ROUTE U.S. 206 At Entrance To Stokes State Forest

CONTRACT NO. 120950525

ADDENDUM NO. 2

**ROUTE 206 AT THE ENTRANCE TO STOKES STATE FOREST
CONTRACT NO. 120950525
SUSSEX COUNTY**

ADDENDUM #2
ATTACHMENT #1

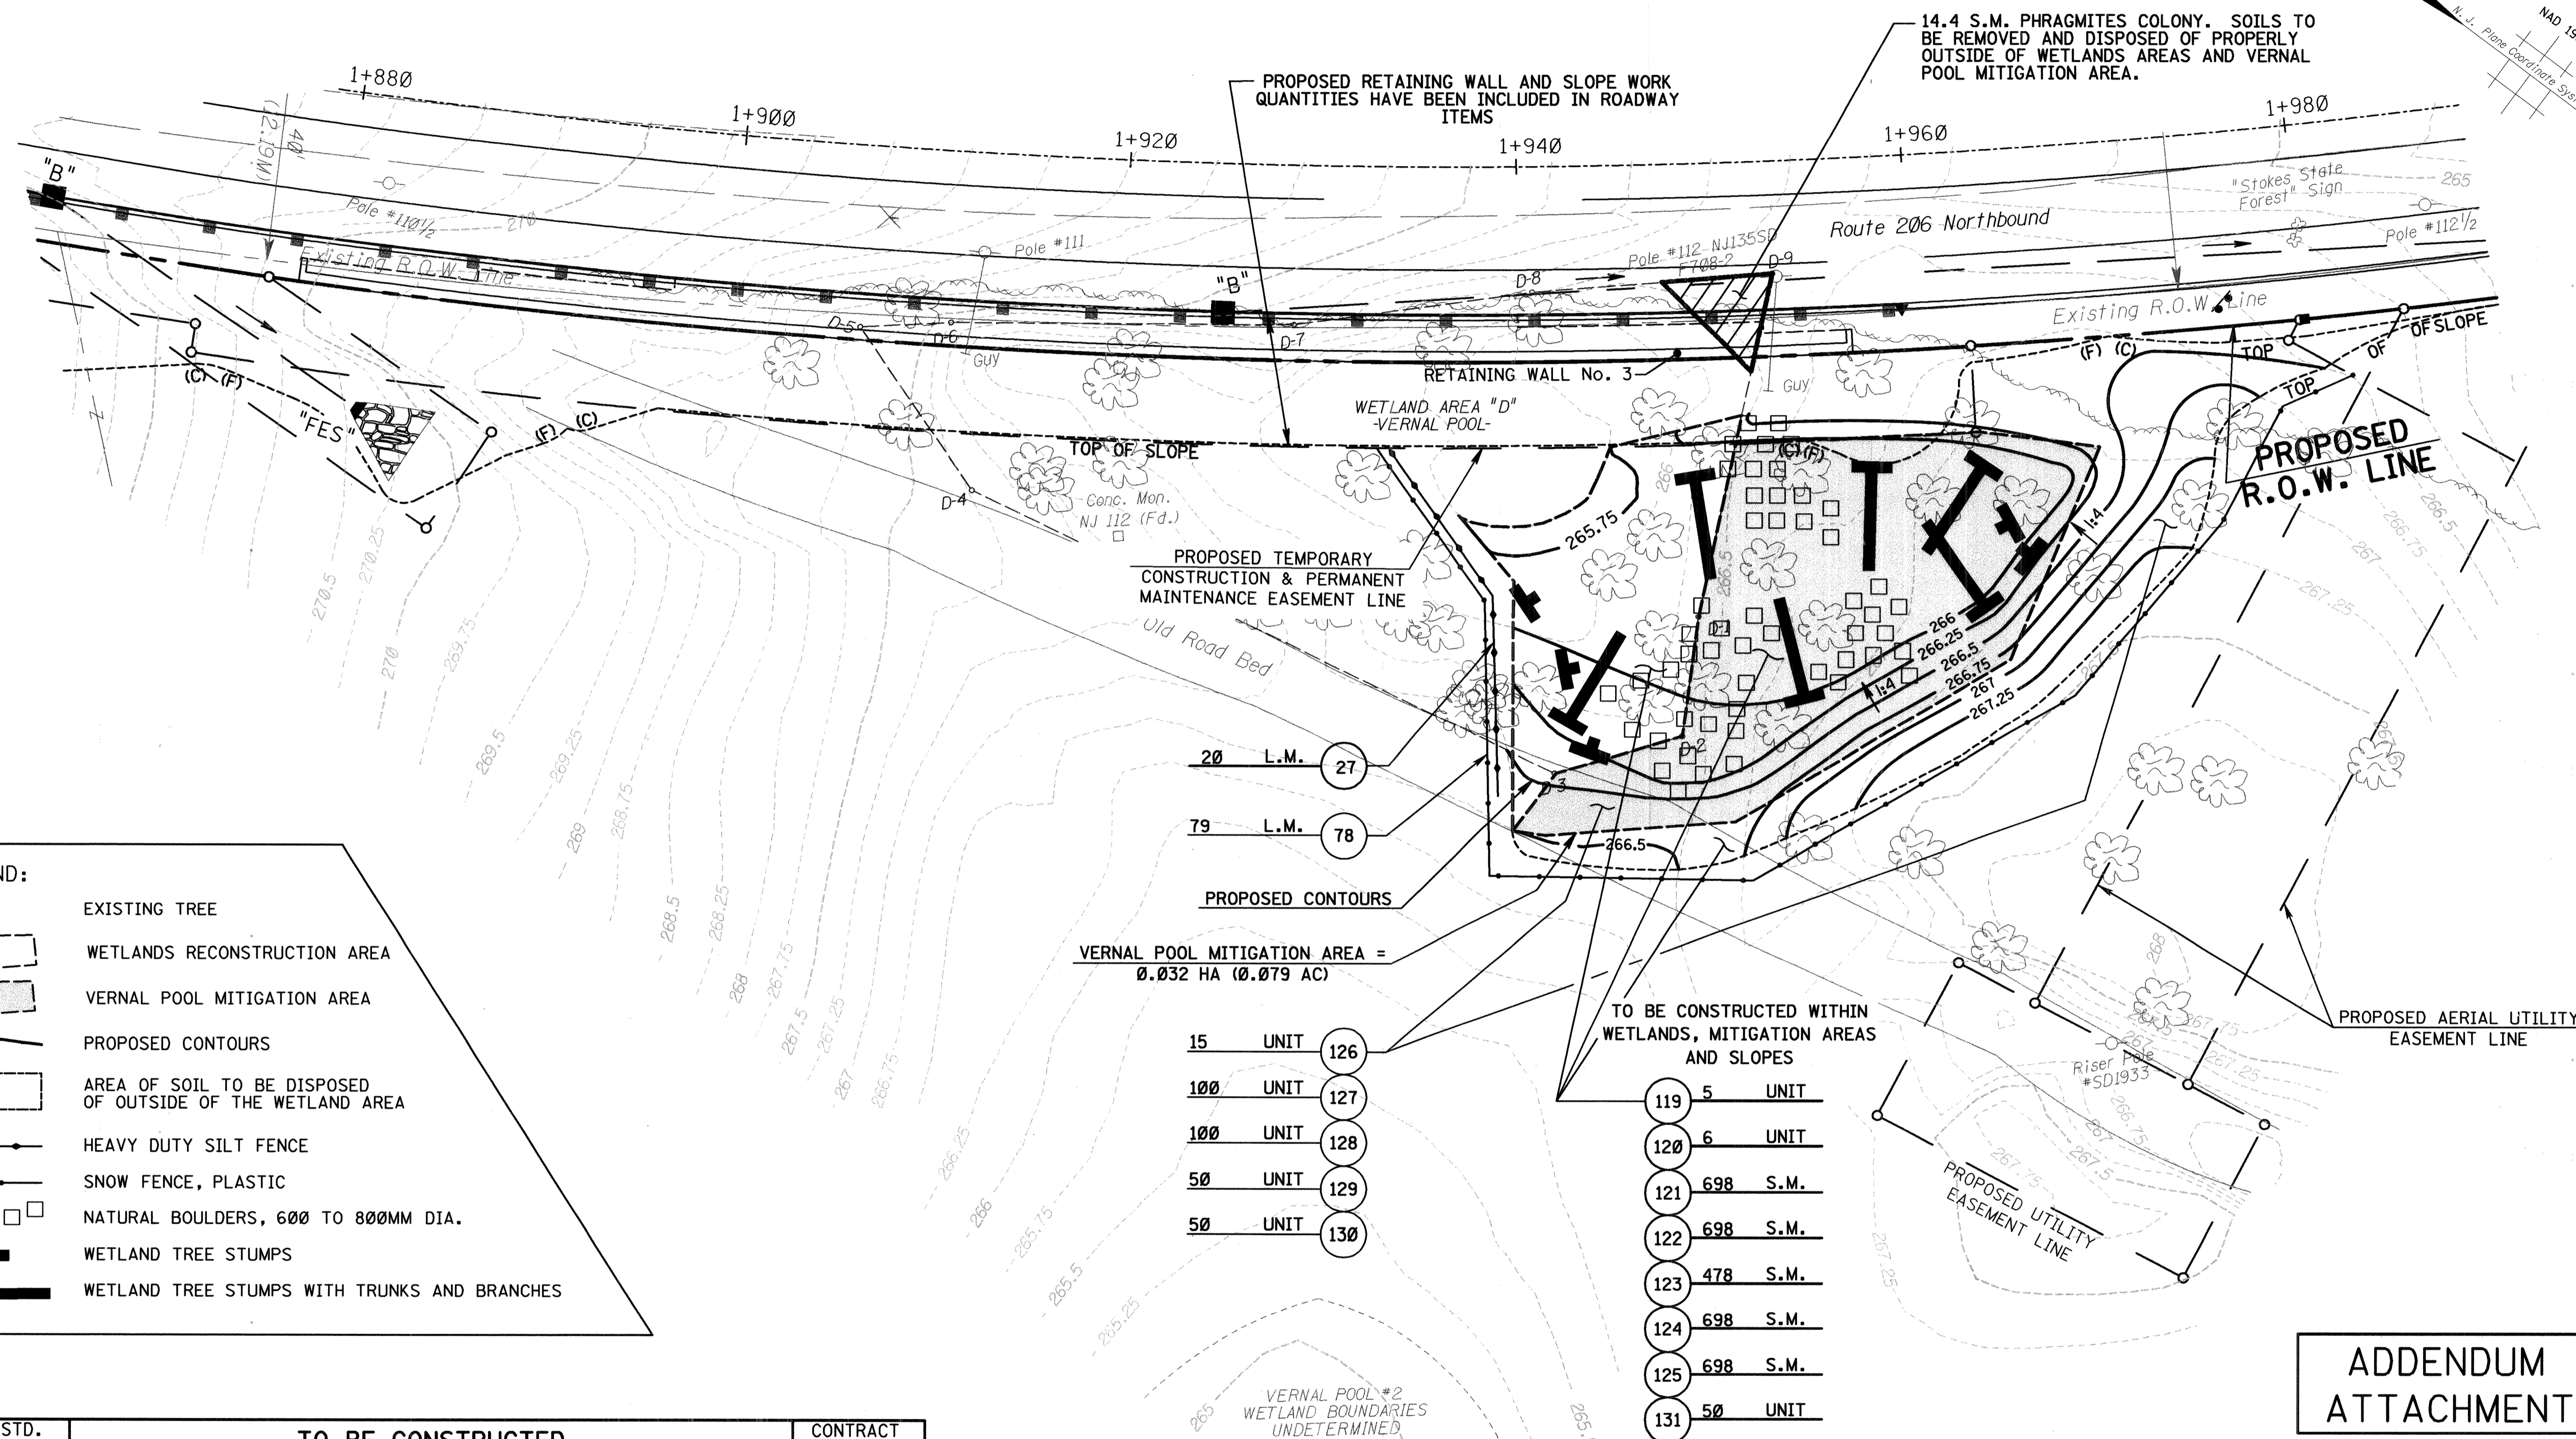
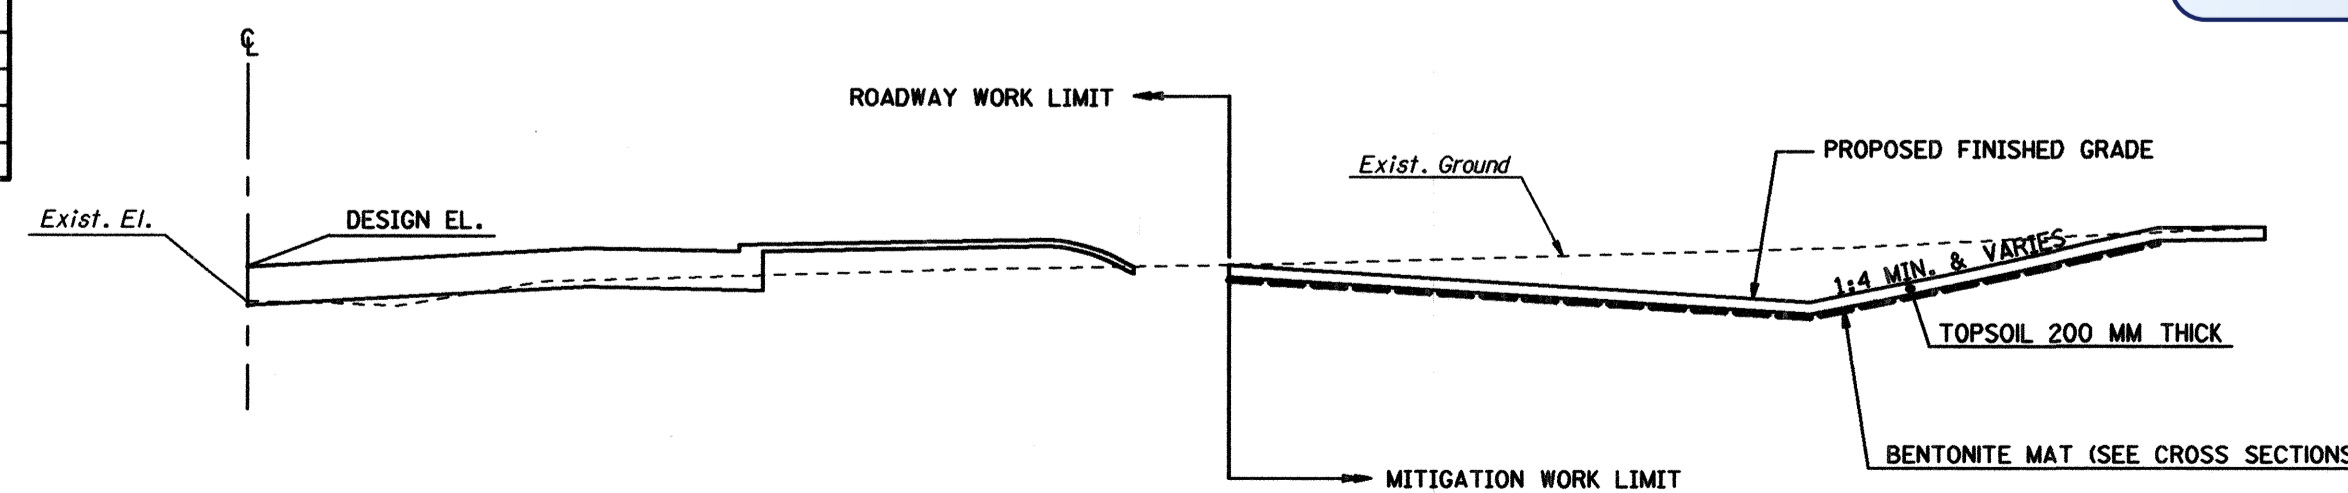
Attachments 1 through 3 inclusive, of Addendum Number 2 are **ADDED** to the plans.

ADDENDUM #3
ATTACHMENT #6

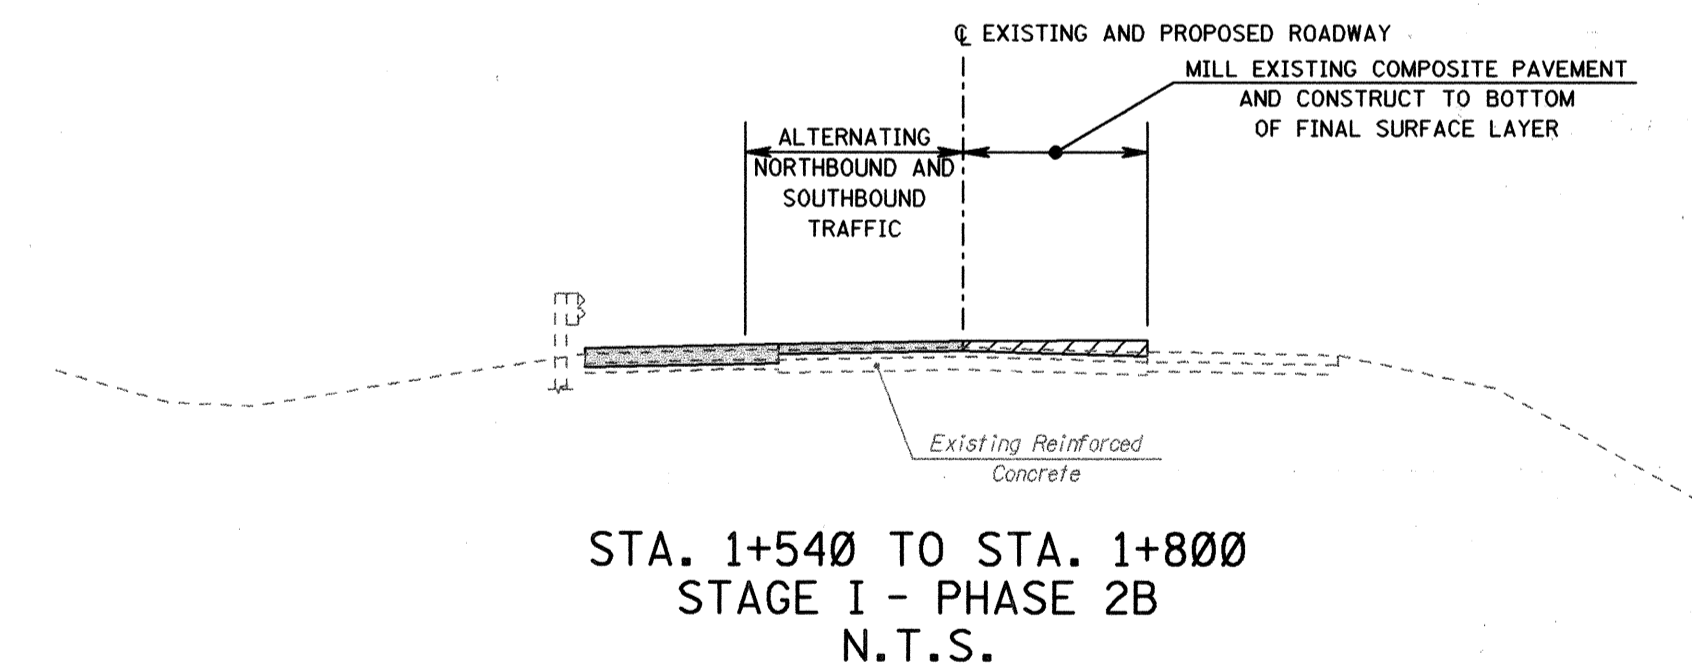
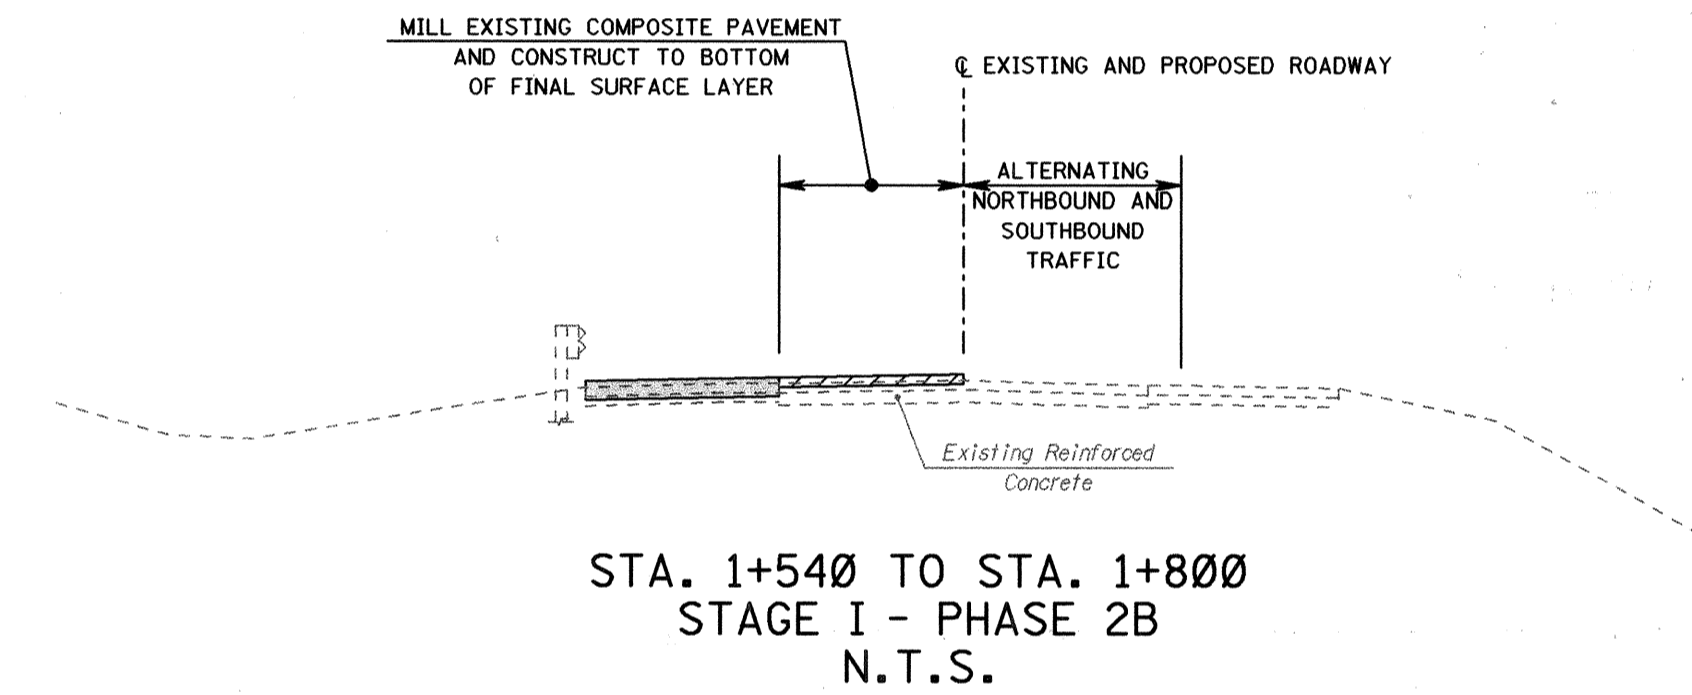
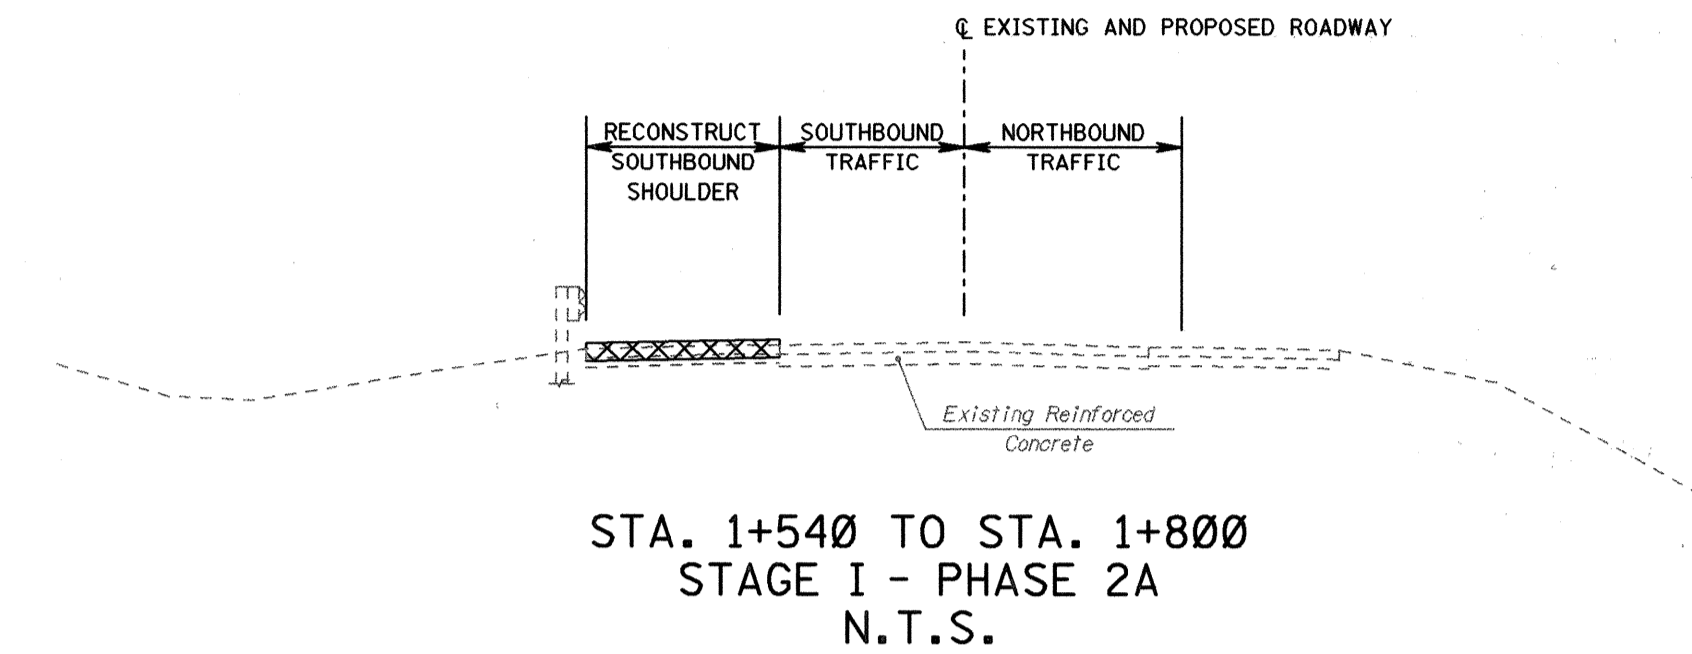
ATTACHMENTS 1 through 16 of Addendum 3, **REPLACE** the following original sheets:

ATTACHMENT NUMBER	ORIGINAL SHEET NUMBER
1	9
2	10
3	11
4	21
5	22
6	37
7	38
8	39
9	40
10	41
11	42
12	43
13	44
14	72
15	73
16	74
